TE Connectivity

Product Change Notification: PCN-21-111259

legacy 0.5FH 220pos rec & plug connectors

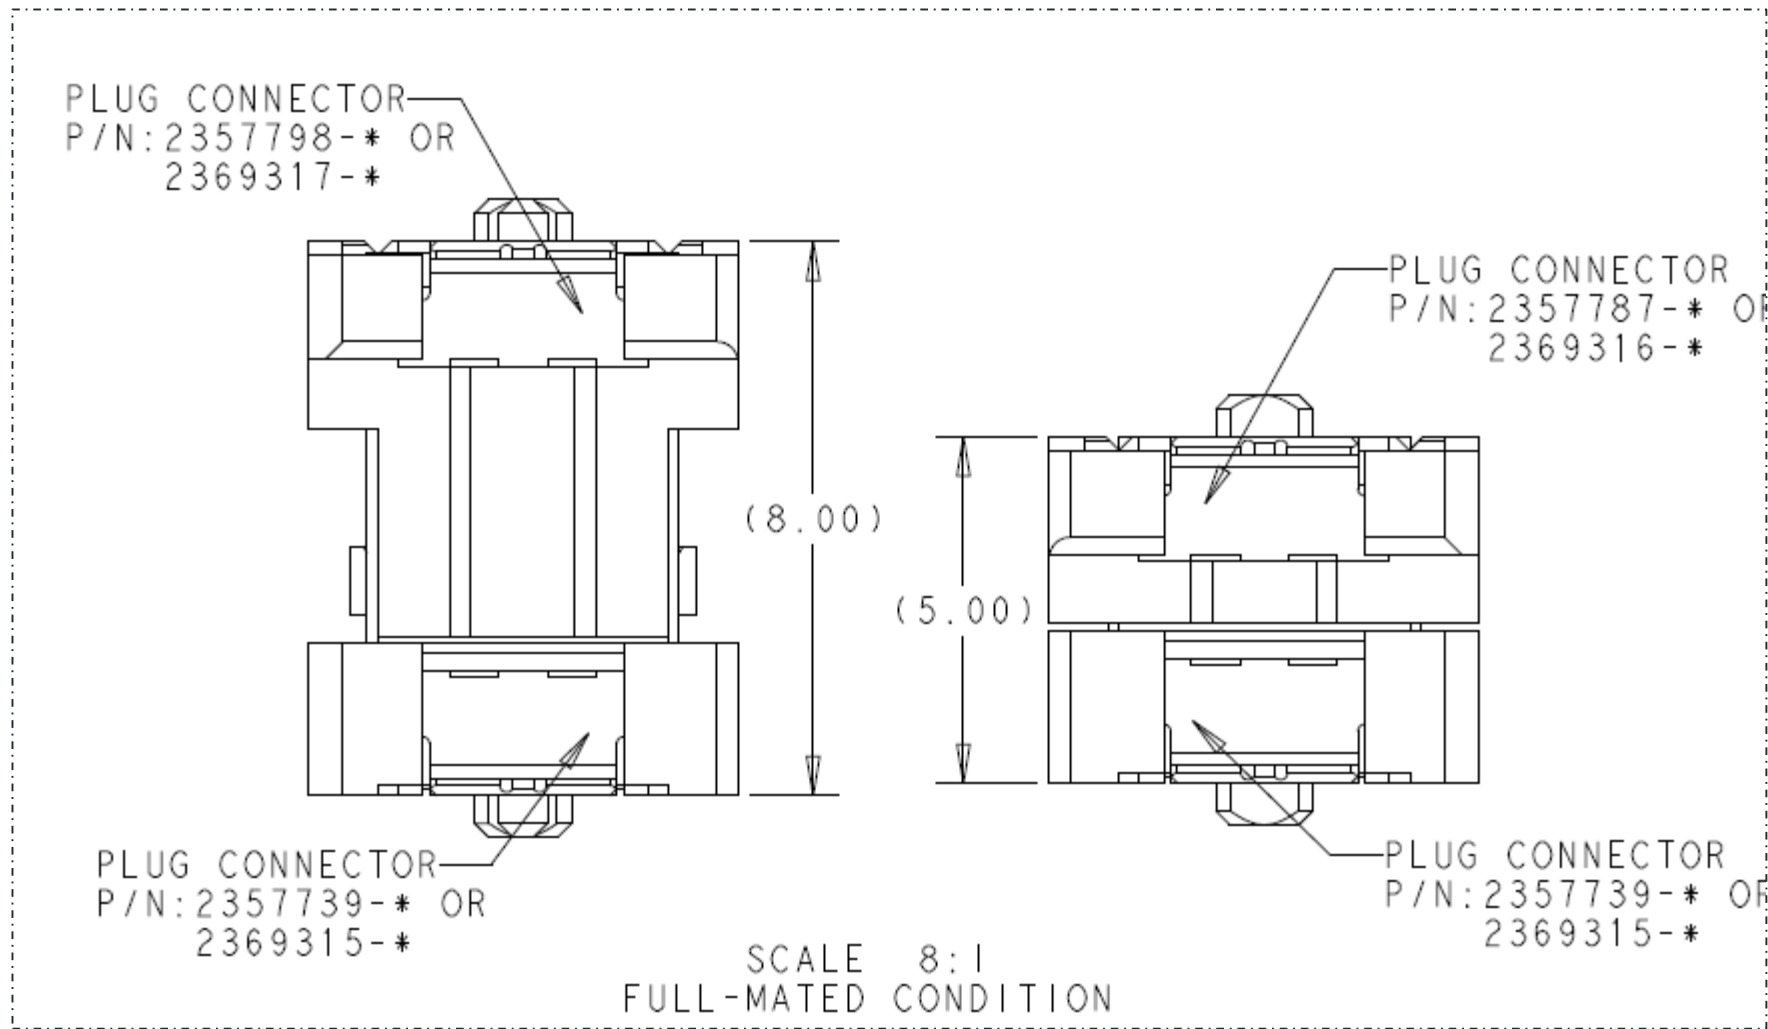
Add the similar the above info in the customer drawings, here 16G COMe connectors for example
